# **RANCHO SANTIAGO COMMUNITY COLLEGE DISTRICT**

## **ADDENDUM NO. 02**

Bid #1434  
at  
CAMPUS ENTRANCE IMPROVEMENT – PHASE 1 PROJECT

Project ID #3739, DSA #04-121029

**DATE ISSUED:** 2018-11-19  
**PROJECT NO:** 2018-40167  
**DSA APPLICATION NO:** 04-121029  
**SCALE:** As indicated  
**SHEET NUMBER:** E-501  
**SHEET TITLE:** DETAILS

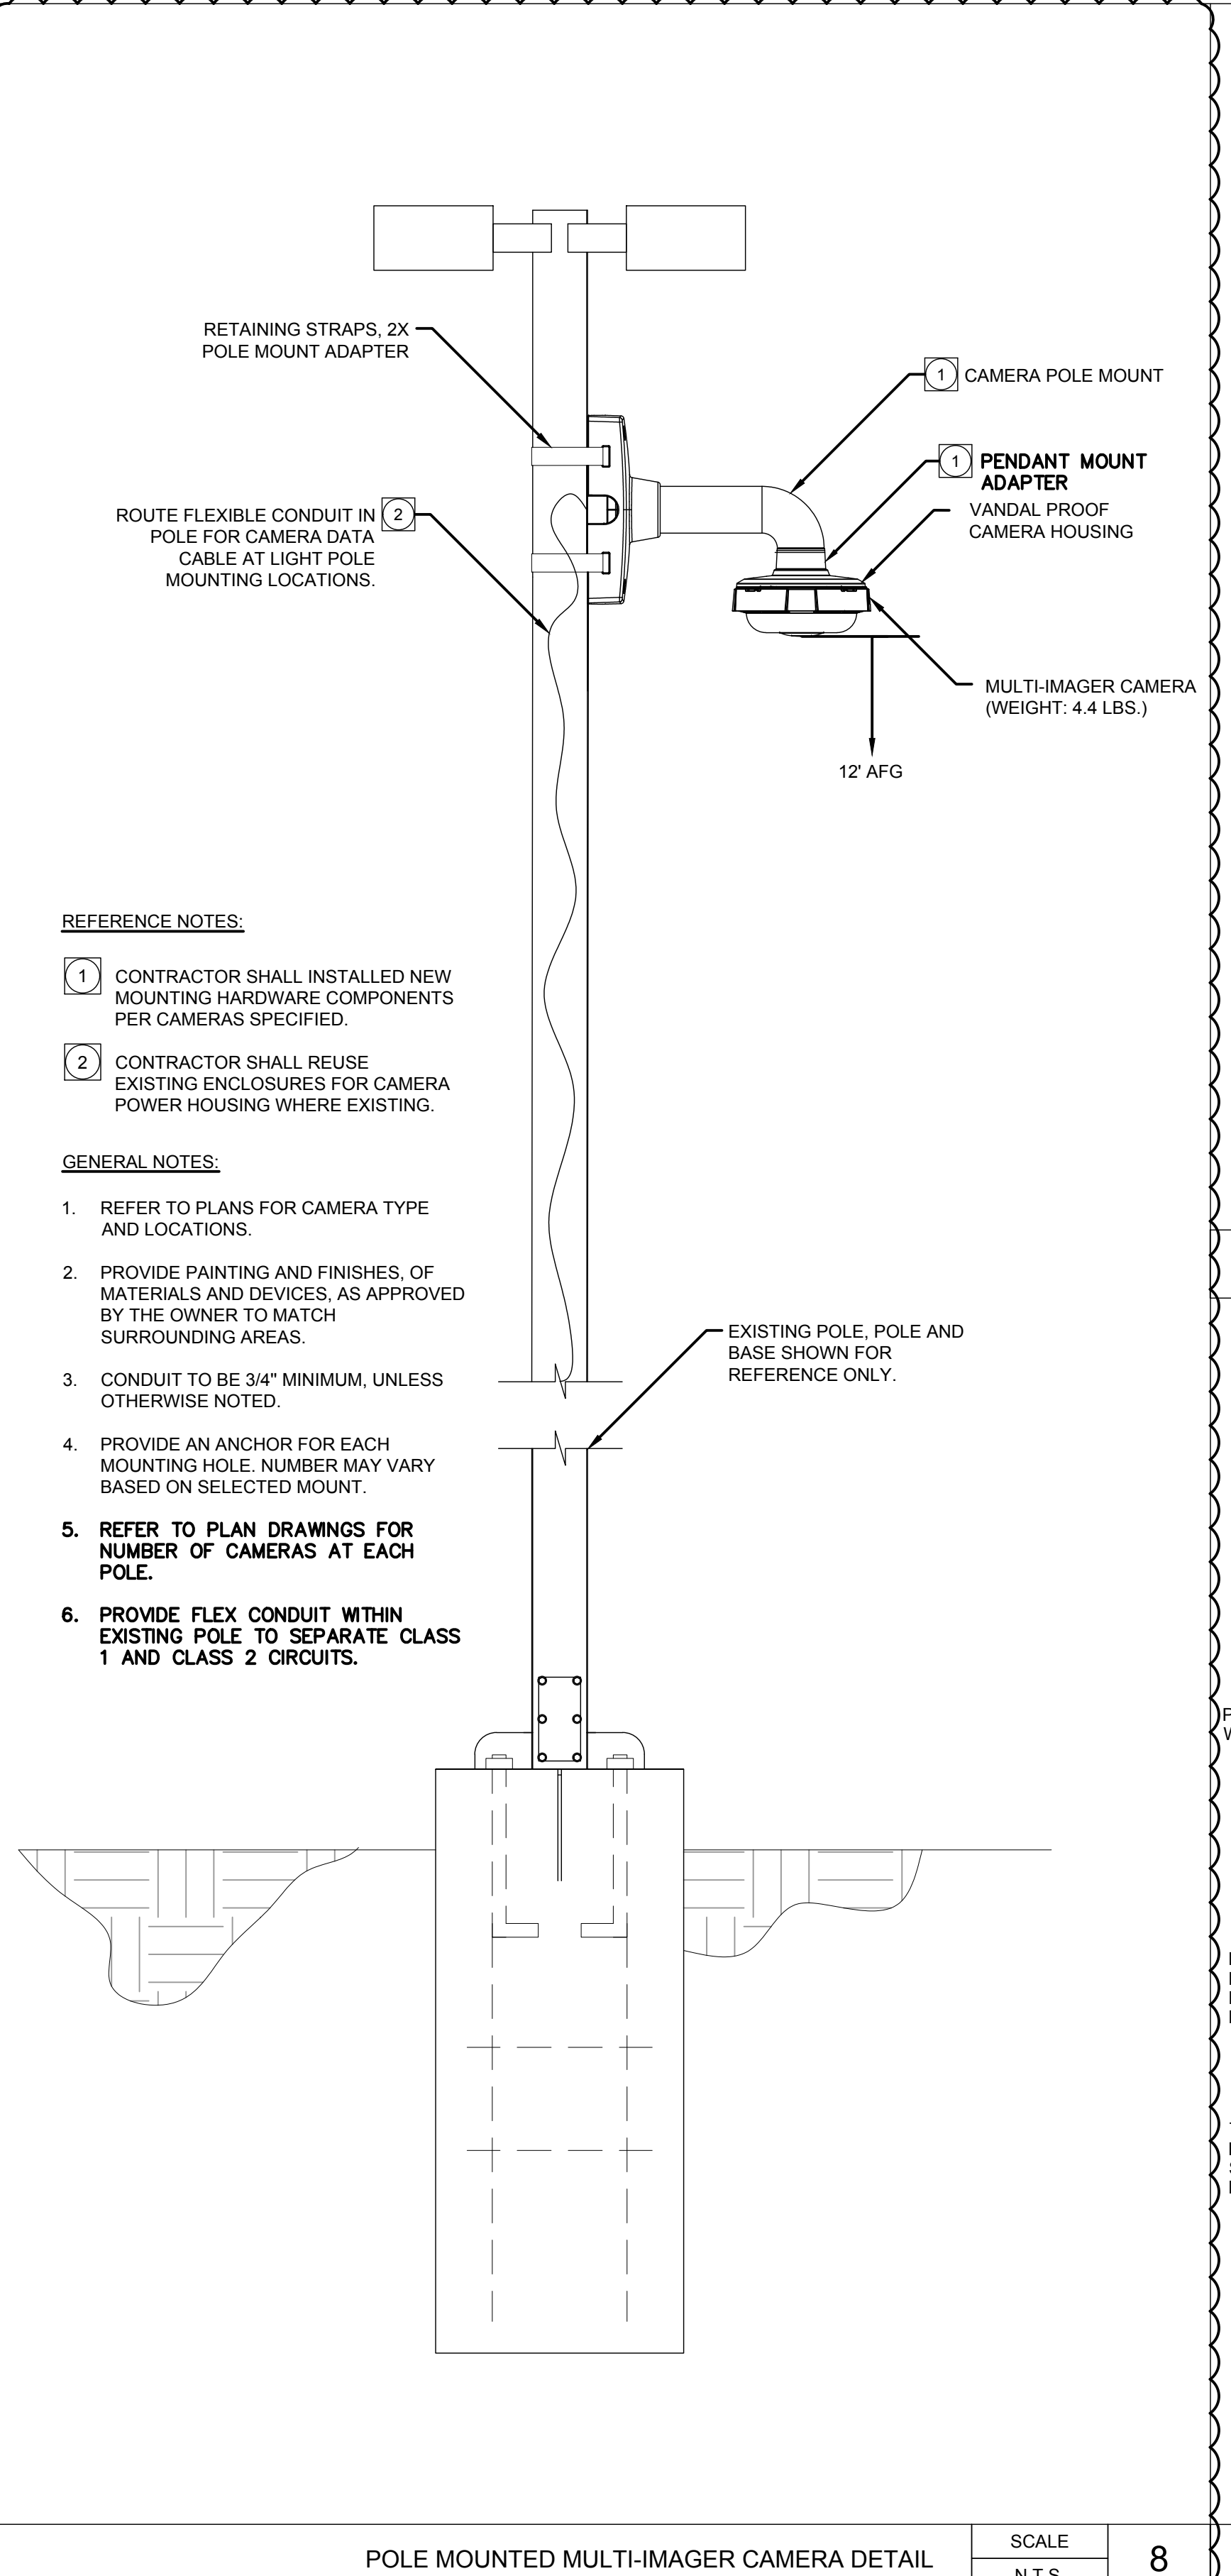
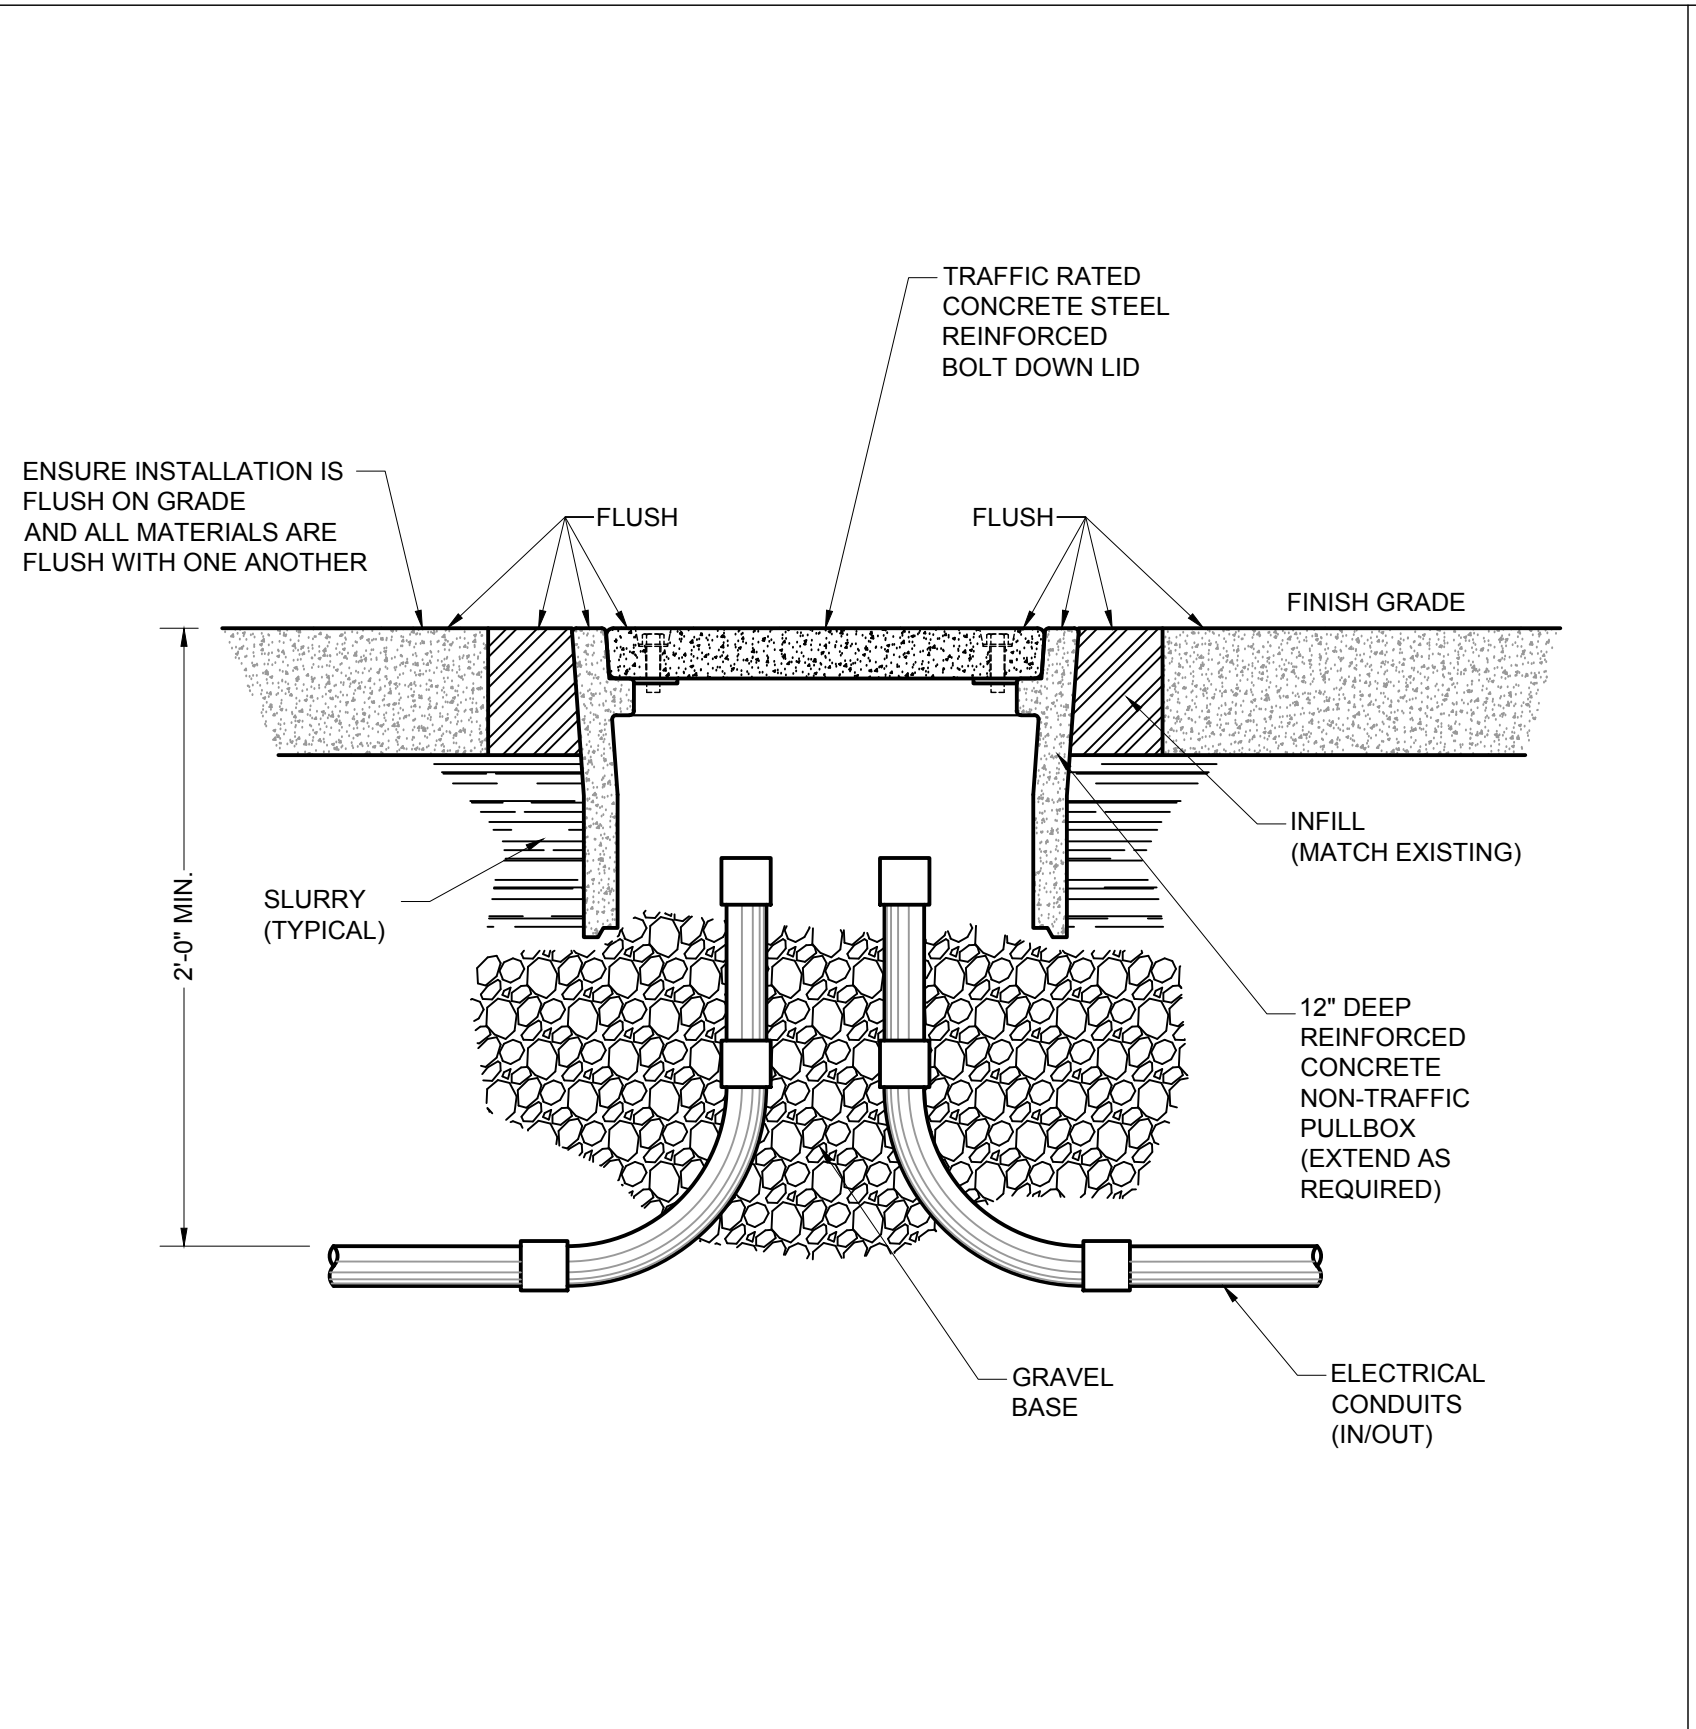
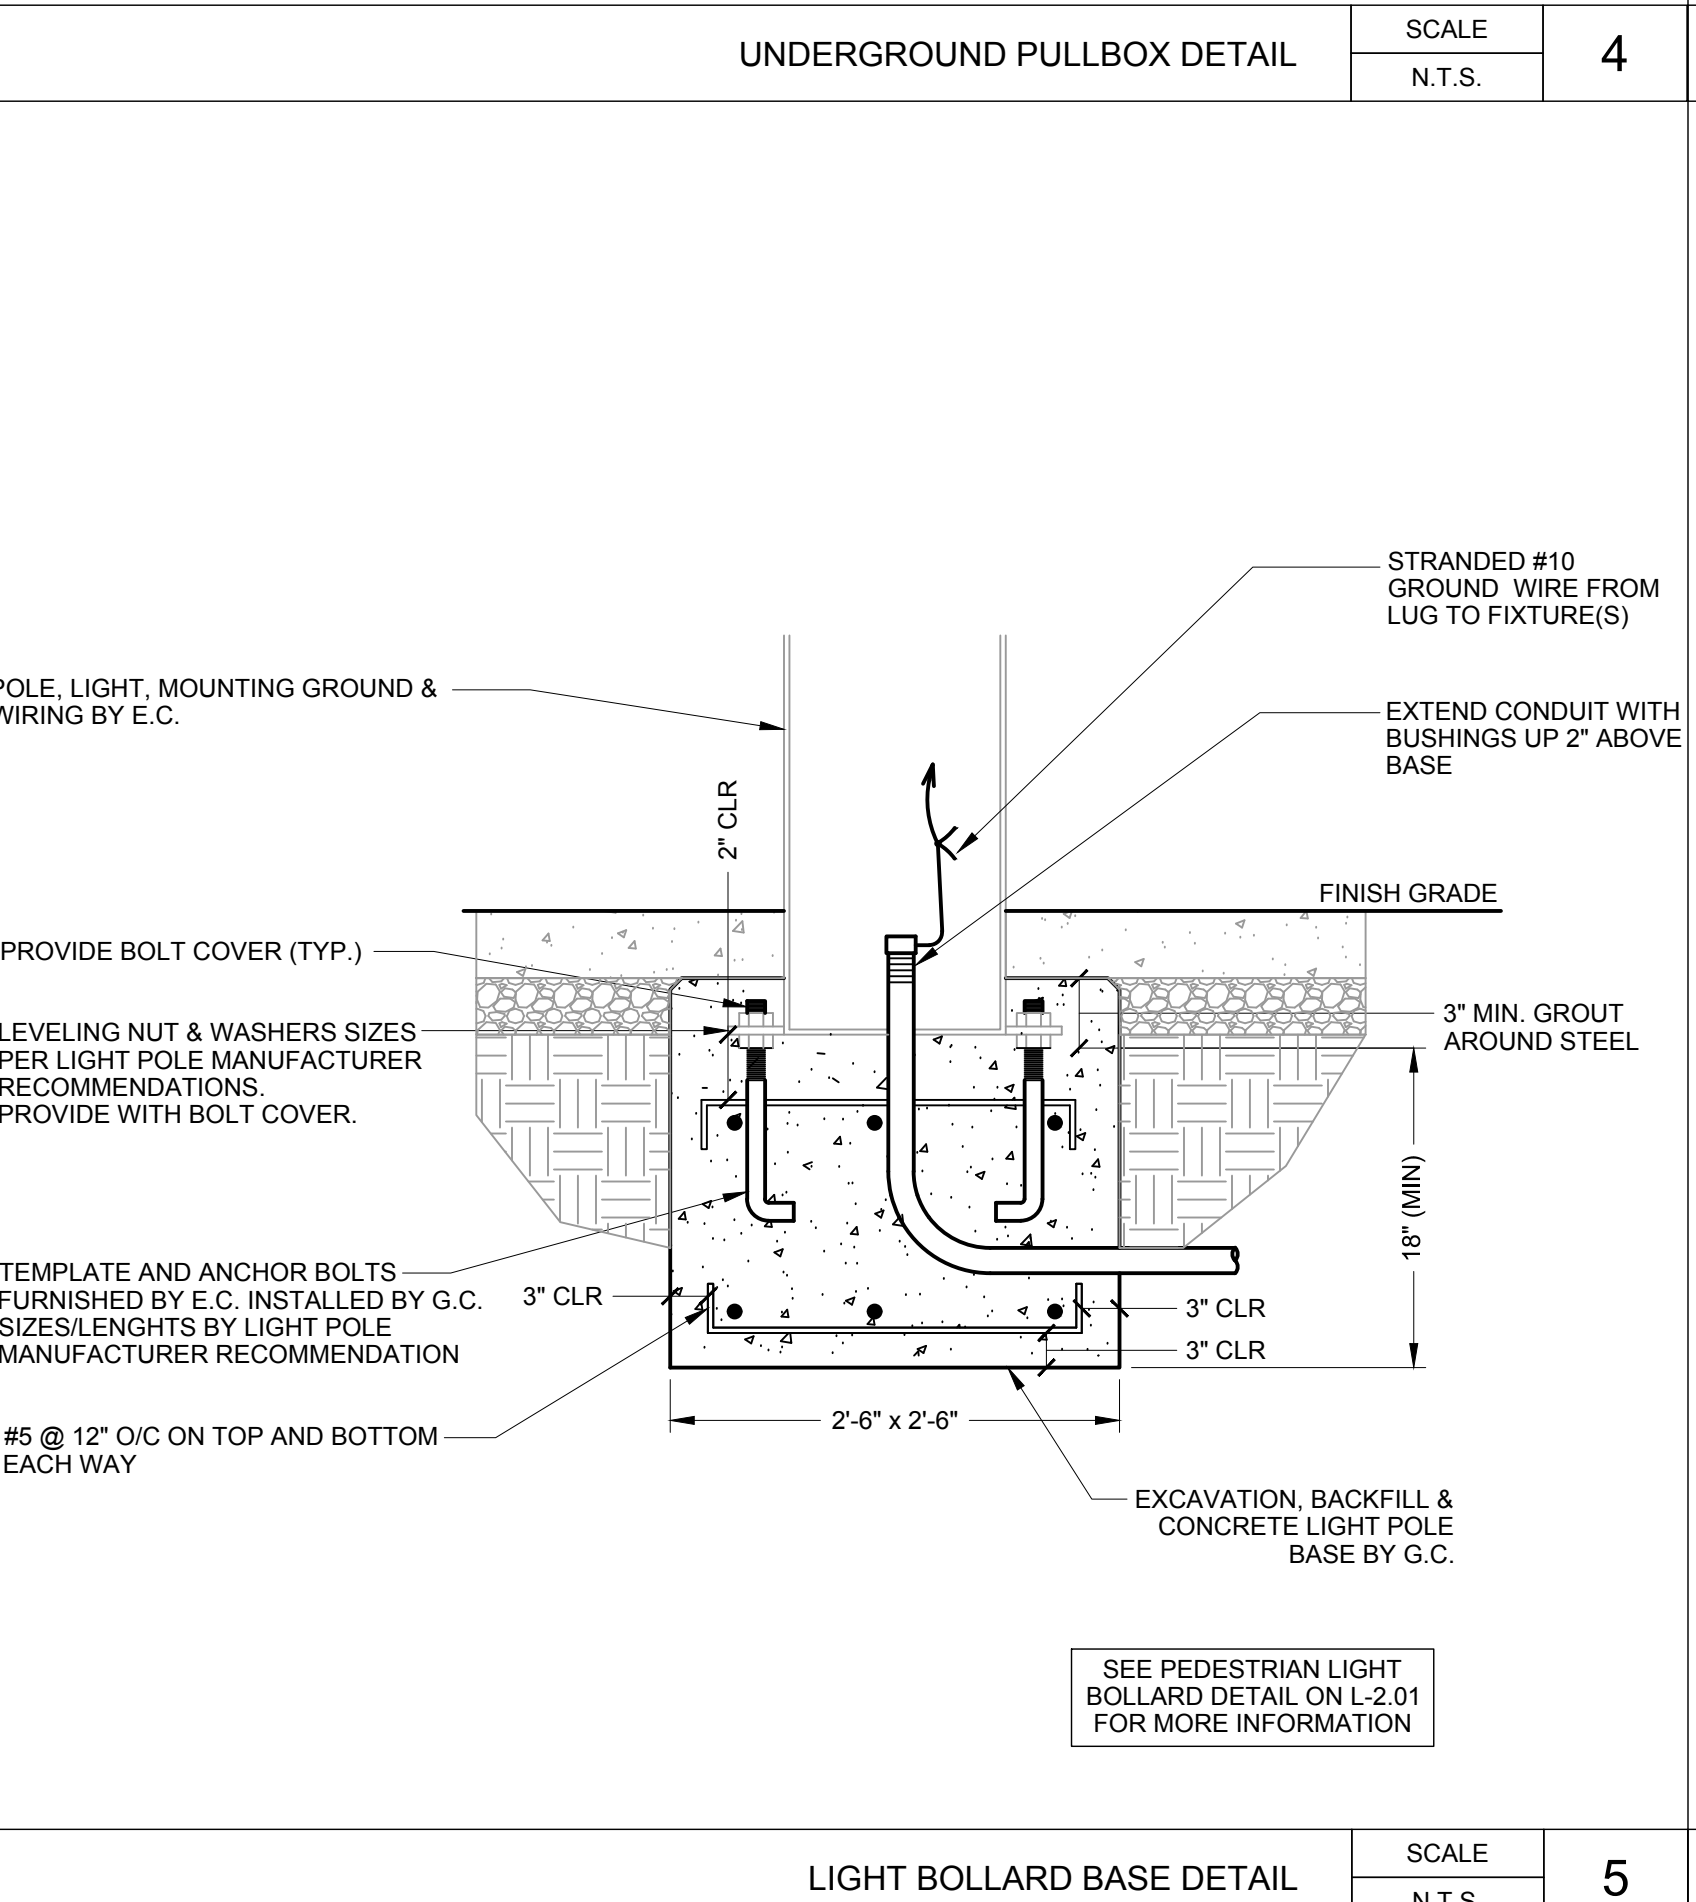
Provide a brief description of construction scope for this post-approval document (attach additional sheets if needed): <u>Updated sheets CD-1.3, C-4.1 &amp; C-5.2 to remove an existing gate valve by adding a note and detail. Revised note on Landscape detail G/L-4.01 to use PVC SCH.40 and detail H to use SCH.80 nipple MIPT and slip match valve size. Added note on sheet L-501 to add root barrier at trees within 8-ft. of hardscape. Added note #4 on 6/L-6.01 to add 4-inch mulch layer. Updated the electrical sheets to add a note and detail to add addition security cameras.</u>			
List of DSA-approved drawings affected by this post-approval document: <u>Civil sheet(s): CD-1.3, C-4.1, C-5.2, Landscape sheets: L-4.01, L-5.01, L-6.01 and Electrical Sheet(s): E-103 and E-501</u>
